Agenda
City of Springboro Planning Commission Meeting
Wednesday, November 16, 2022, 6:00 p.m.
Council Chambers, City Building, 320 West Central Avenue

Rezoning, Stoneridge Development, southwest corner of East Central Avenue (SR 73) and Red Lion-Five Points Road, Clearview Crossing residential subdivision

Site Plan Review, 800 West Central Avenue (SR 73), proposed Sheetz fuel center, convenience store/restaurant

CONCRETE SIDEWALK

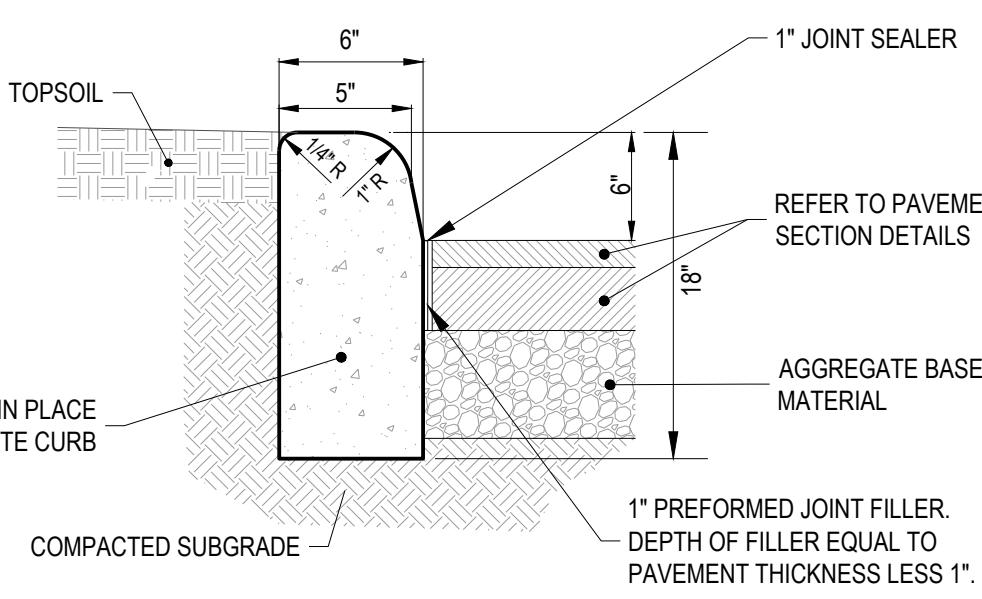
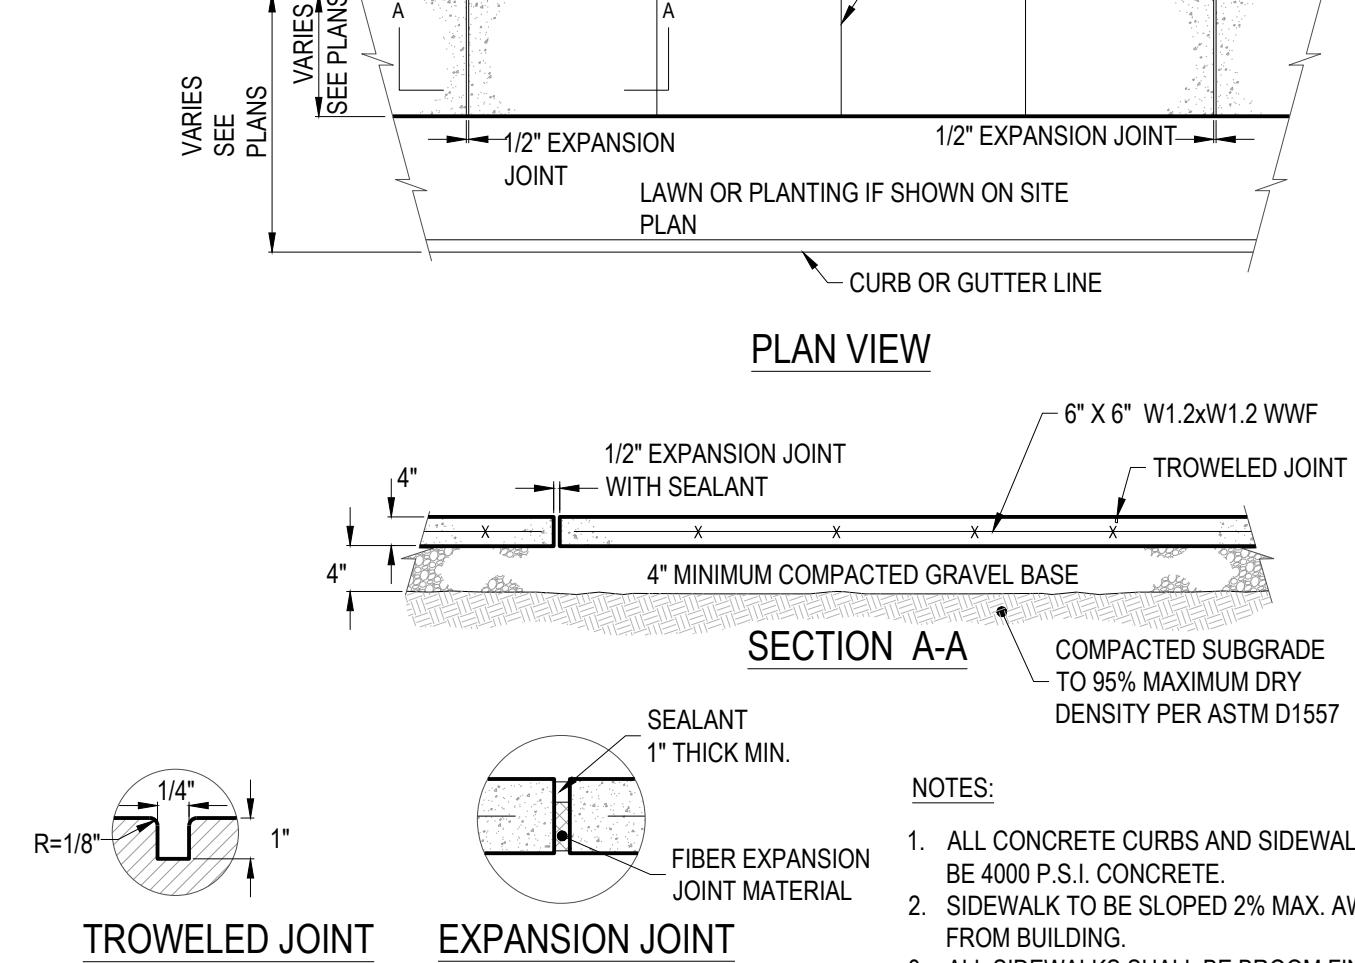
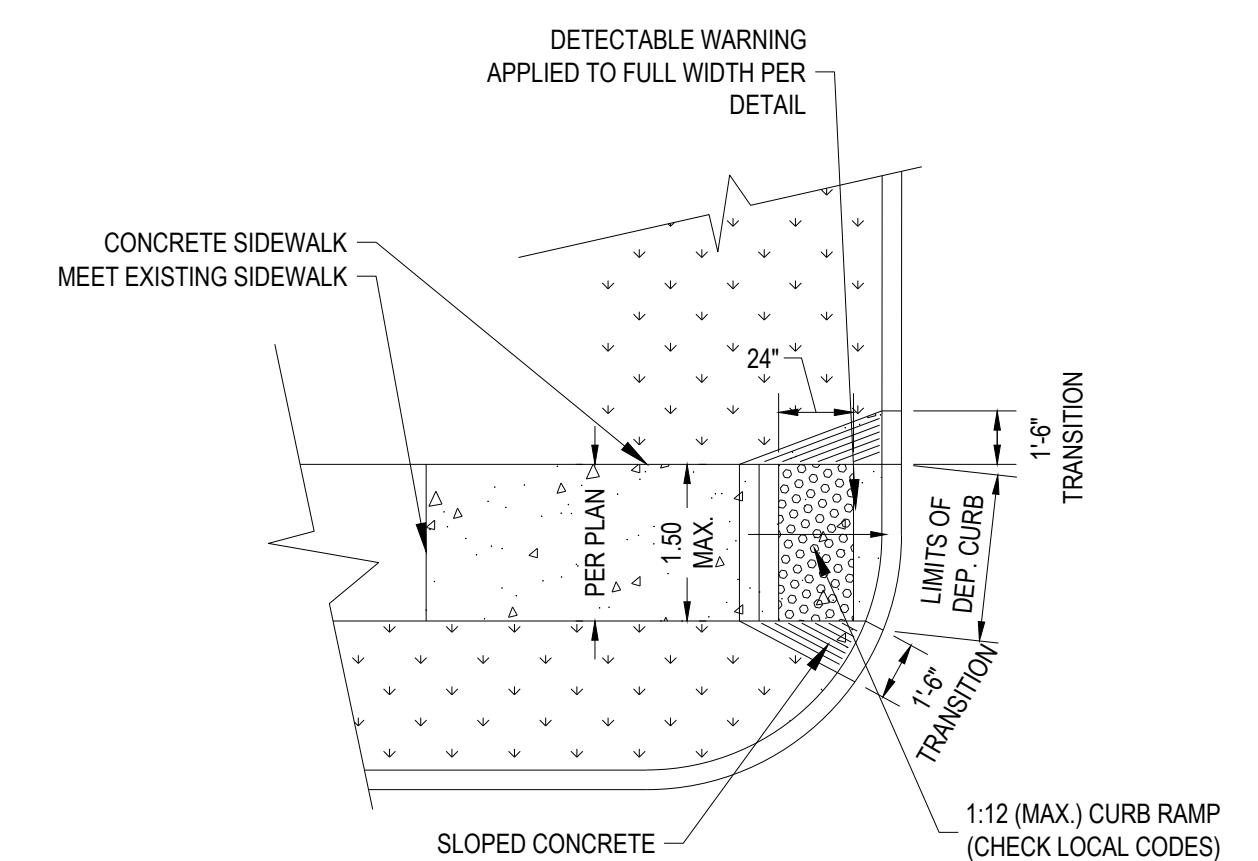
17. Proposed sidewalk along Tahlequah Trail to be 6 feet wide due to it being located directly behind curb; revise sidewalk detail on sheet C7.2.
18. Provide centerline pavement markings along Tahlequah Trail.

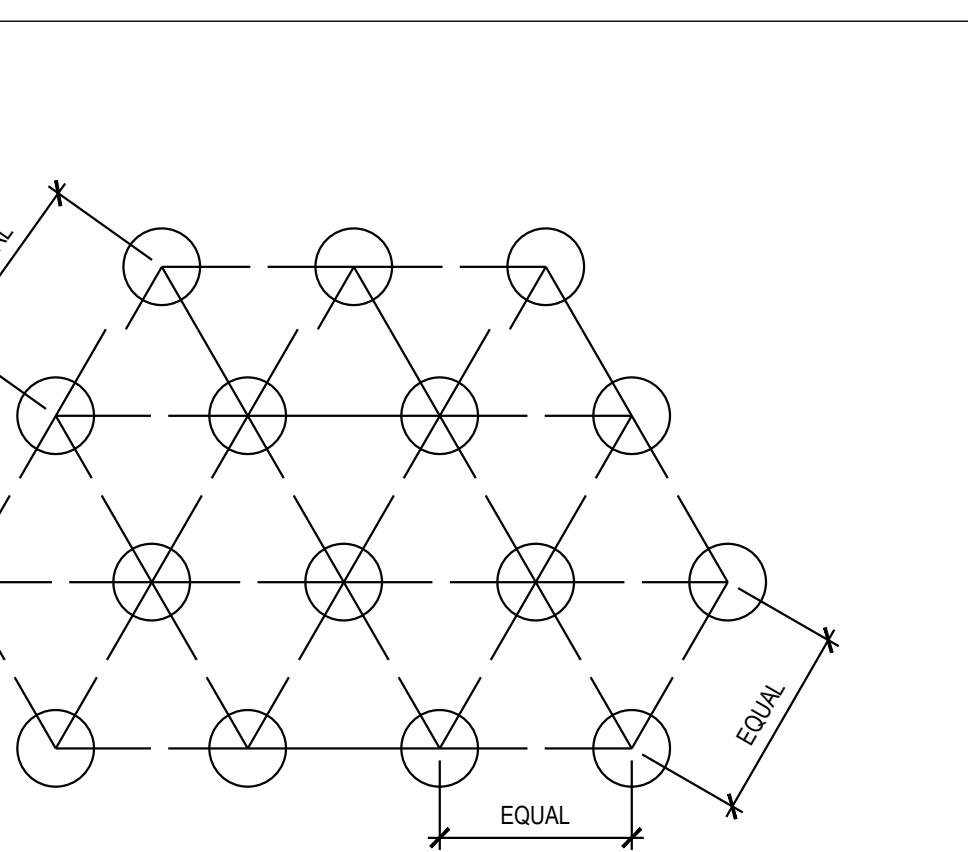
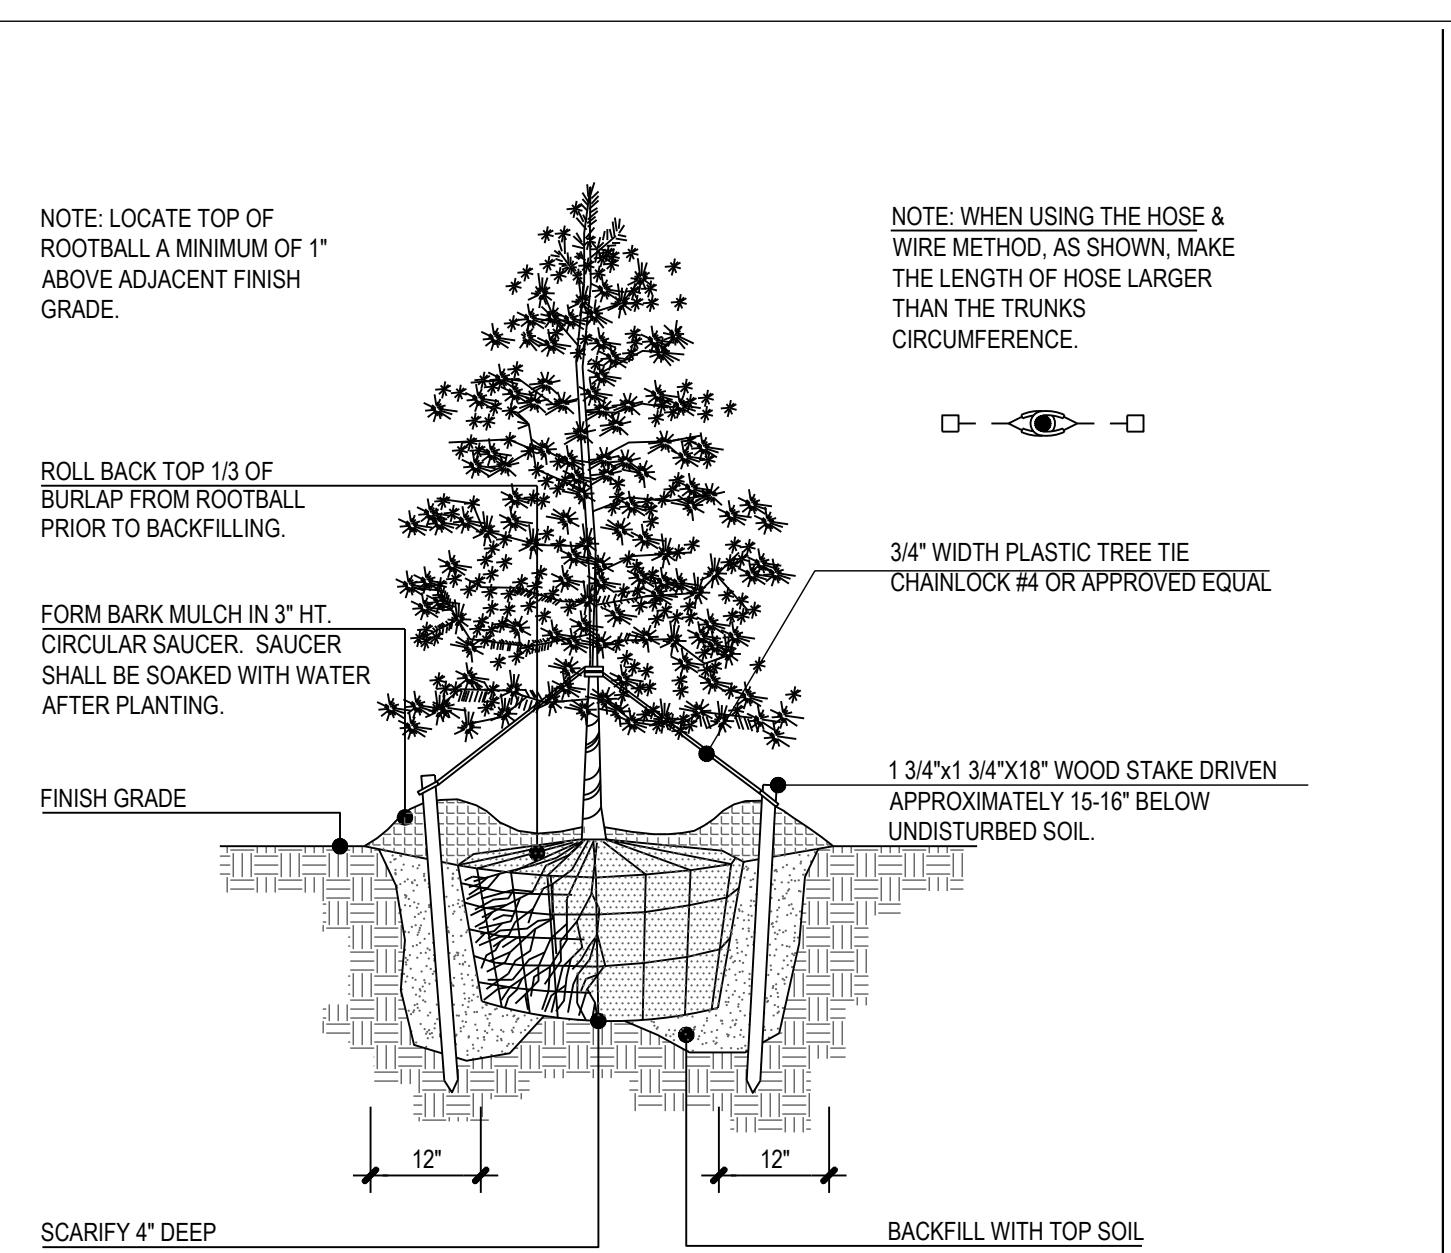
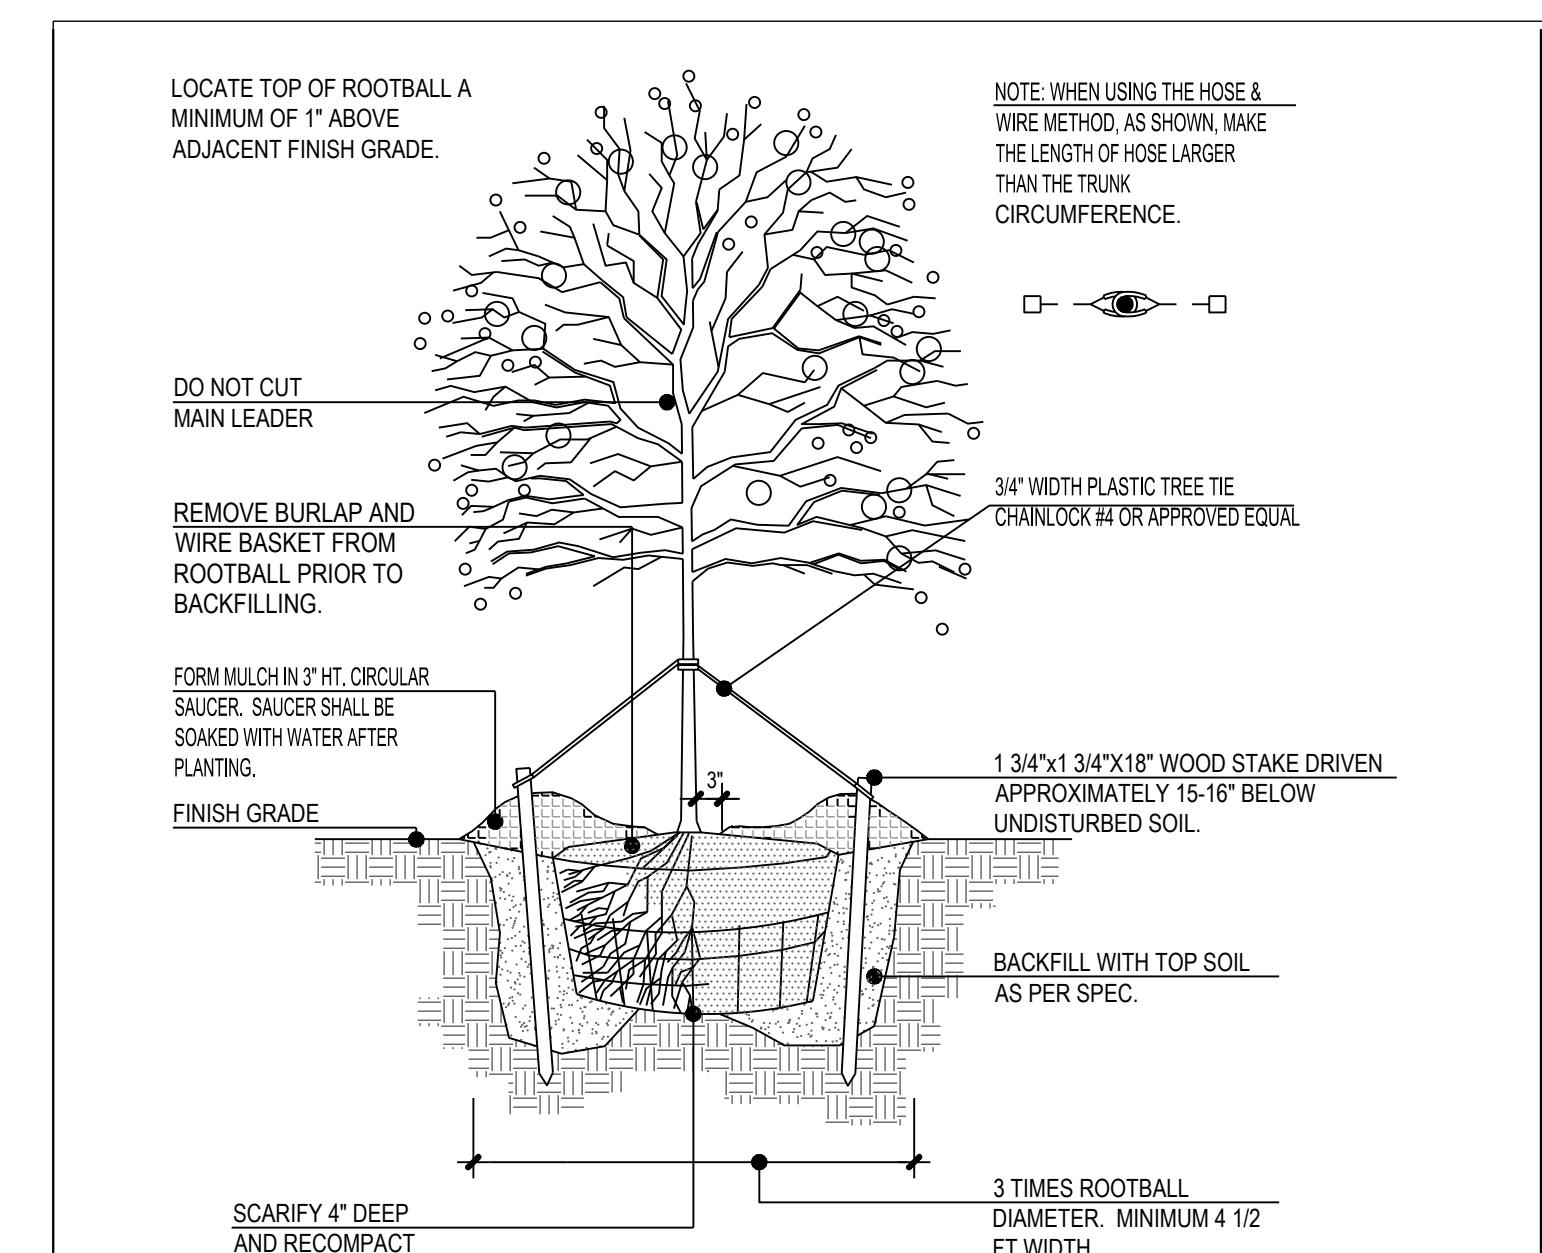
- d. Average to maximum (4:1 permitted) and minimum to maximum (10:1) ratio are exceeded on the photometric analysis. Revise plan accordingly.
2. Landscaping plan (sheet L1.0) correctly addresses buffer, parking lot, and site requirements, however coordinate with City staff to identify plantings to comply with requirements in particular site requirement. Landscaping plan may need to be revised to incorporate circulation and access comments. Provide documentation of the manner in which landscaping will screen the fueling center per the provisions of Section 1264.25 of the Planning and Zoning Code as discussed at the October 12th meeting.
